**INTERNATIONAL CODE COUNCIL (ICC)
Code Technology Committee (CTC)**

**INTERIM REPORT NO. 2 OF THE CTC
AREA OF STUDY – CLIMBABLE GUARDS**

**October 19, 2006
Hilton Kansas City Airport**

The following is an illustration of the measurement. The view is taken from the landing of a 3 riser stair, looking towards the face of the risers.

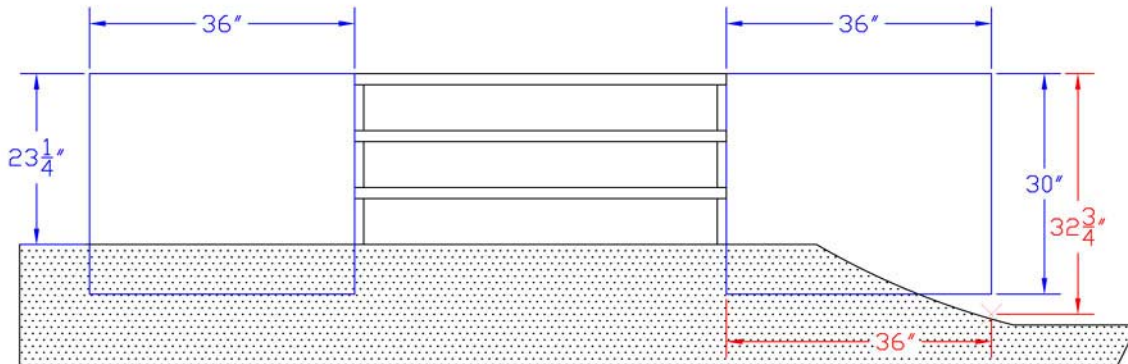
Recommendation: The CTC Interim Recommendation Number 2 is to submit a public comment to code change E96-06/07. This public comment will incorporate revised wording from code change E97-06/07 in order to address the measurement from the walking surface to the edge of the open side to determine if a guard is required (see figure on page 2).

- The code does not stipulate how to measure of the 30 inch height guard threshold where the adjacent grade is sloping.

1013.1 Where required. Guards shall be located along open-sided walking surfaces, including mezzanines, industrial equipment platforms, stairways, stairs, ramps and landings, that are located more than 30 inches measured vertically to the floor or grade below at any point within 36" horizontally to the edge of the open side above the floor or grade below. Guards shall be adequate in strength and attachment in accordance with Section 1607.7. ~~Where glass is used to provide a guard or as a portion of the guard system, the guard shall also comply with Section 2407.~~ Guards shall also be located along glazed sides of stairways, ramps and landings that are located more than 30 inches (762 mm) above the floor or grade below where the glazing provided does not meet the strength and attachment requirements in Section 1607.7.

R312.1 Where Guards required. ~~Porches, balconies, ramps or raised walking floor surfaces located more than 30 inches above the floor or grade below shall have guards not less than 36 inches in height. Open sides of stairs with a total rise of more than 30 inches above the floor or grade below shall have guards not less than 34 inches in height measured vertically from the nosing of the treads.~~ Guards shall be located along open-sided walking surfaces, including porches, decks, balconies, mezzanines, stairs, ramps and landings, which are located more than 30 inches measured vertically to the floor or grade below at any point within 36" horizontally to the edge of the open side. Insect screening shall not be considered as a guard.
